Natural Denims Ltd

Tonga bari, Ashulia, Dhaka
(+23.901N, 90.3259E)

22 September 2013

**Clad steel framed dining
area located at roof
level**

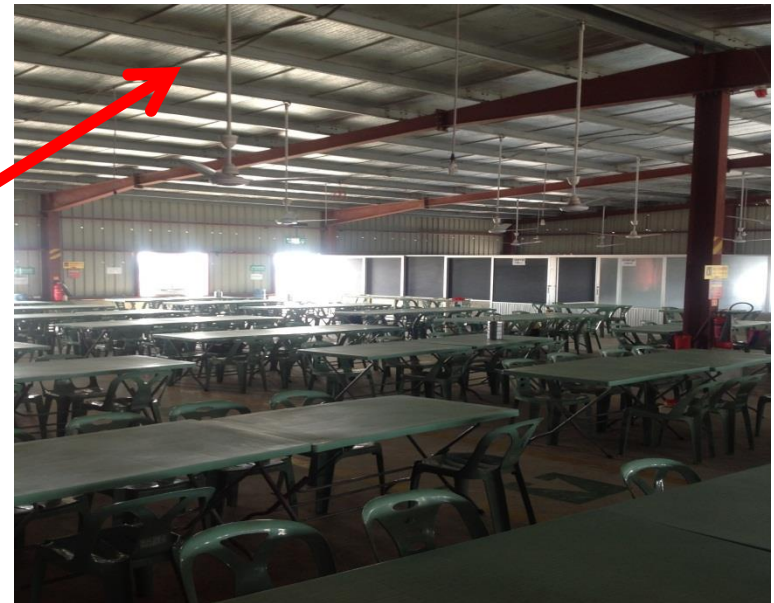
Steel frame supported on the concrete roof slab has no obvious horizontal stability system, in the plane of the steel roof, to resist high wind loads.

**Roof system has no
obvious horizontal
bracing to provide
stability in high winds**

**Significant Floor Loads at 6th Floor Level.
Determine Design Imposed Floor Load
capacity and limit storage loading accordingly**

Heavy Floor loads

Plan and height restrictions to be introduced to prevent future overloading – allow clear accessways

Storage loads to be limited to the building design loads

**Cracking at Interface
Between Main Building and
5 Storey Annex**

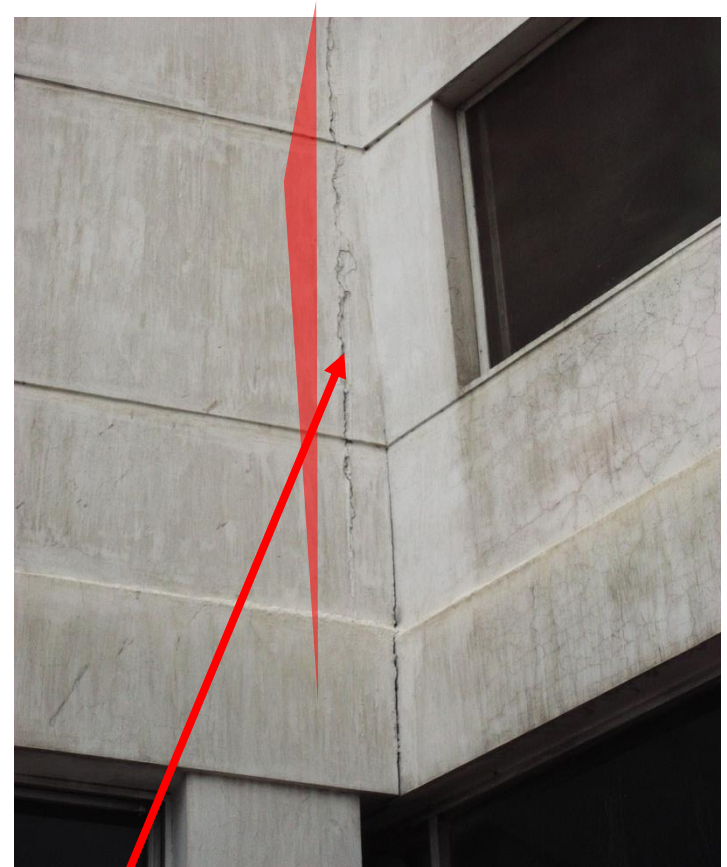
Cracking of perimeter brick façade wall and structural beam at the interface between the 7 storey main building and the 5 storey Annex

**Junction between Annex
and the main building**

- 3rd floor slab and above
are tied structurally
- 2nd floor slab and below
are not tied structurally

**Vertical Crack in Rendered
Brick Façade Wall at South
East Corner of Annex to
Main Building**

Structure at Annex joint line is linked at the upper floors

Cracking along internal beam at Interface Between Annex and Main Structure
